**Marshall Township
Planning Commission
525 Pleasant Hill Road
Wexford, PA 15090**

May 16, 2016 - 7:00 PM

- ❖ Marshall Village; SP(LD)16-05; Fowler Road and Maple Drive., plans dated 4/12/2016;
deadline: 7/18/2016

I. **SP(LD)16-05: Marshall Village – Land Development Application:**

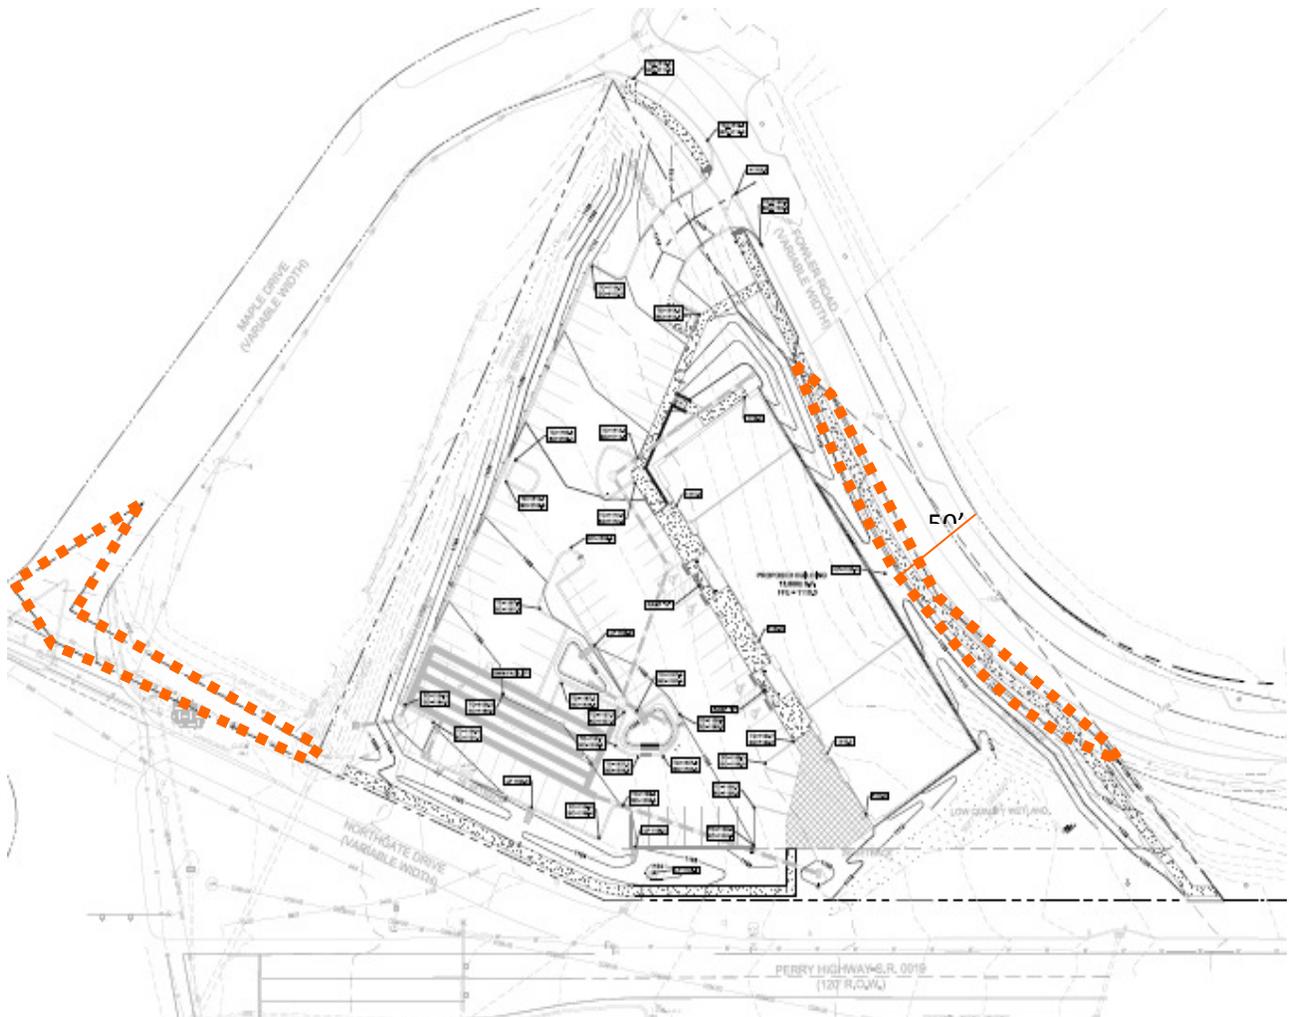
3. The ordinance requires that if a property is subdivided that addition right of way be provided so that a distance of 25' feet from the centerline of the existing right of way to the property boundary is provided, 174-404.E. It is recommended that in this case that the developer consider the dedication of right-of way to address the nonconforming nature of the property. This would apply to the frontages along Fowler Road, the SR 19 off ramp and Northgate Road / Maple Drive. A subdivision recording plan should be prepared for this purpose. The proposed areas are shown in the markup plan below.

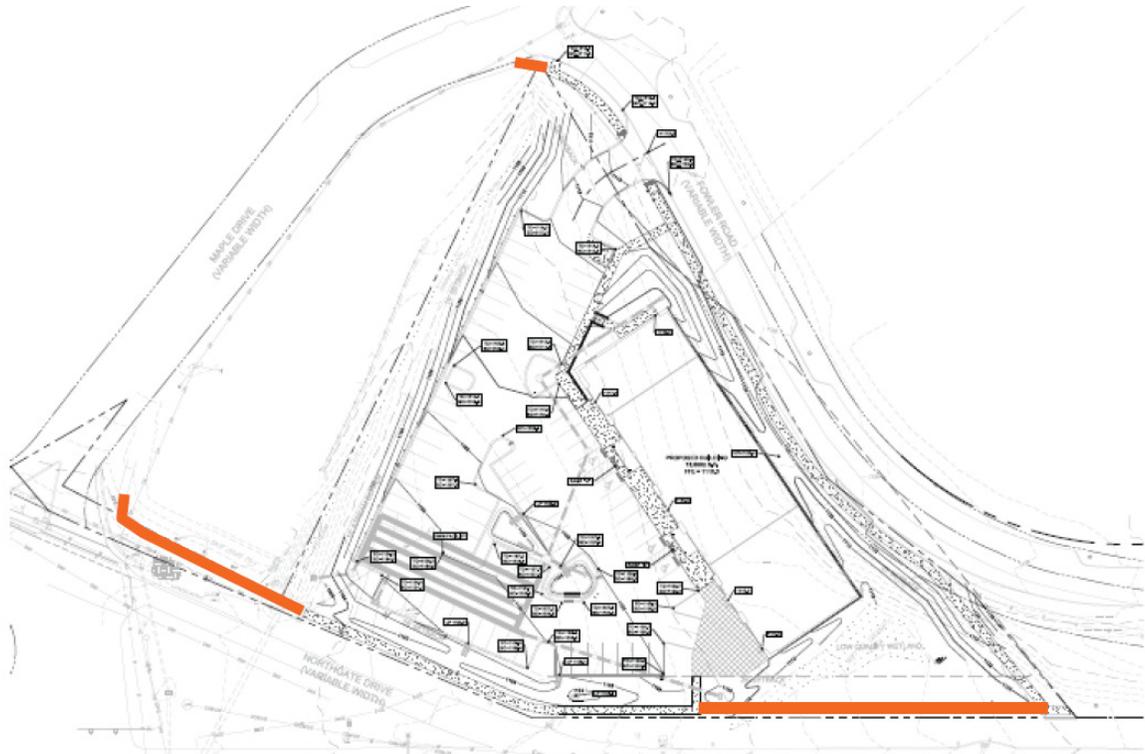
7. The plan should clearly show the limit of PennDOT SR 19 right-of-way, 174-302. The limit of PennDOT right-of-way should also be shown in the area of the off ramp.
8. It appears that an 8" sanitary sewer extension is proposed on plan C-700. This plan should be submitted to Bill Campbell the MTMSA Manager for review, 174-207. Is a boring proposed? A ramp closure and traffic control plan for this work will be required, 174-205.B.11.
9. Set proposed perimeter boundary monuments, 174-207.B.1., and 174-508.
10. Profiles for the entrance road should be provided, 174-404.C.3(c)(i). Please extend to profile to show how it transitions to 5.7% parking lot slope.
11. The ADA Access Ramps should be provided on the Fowler Road sidewalk at the driveway entrance, 174-503.I.2(b).
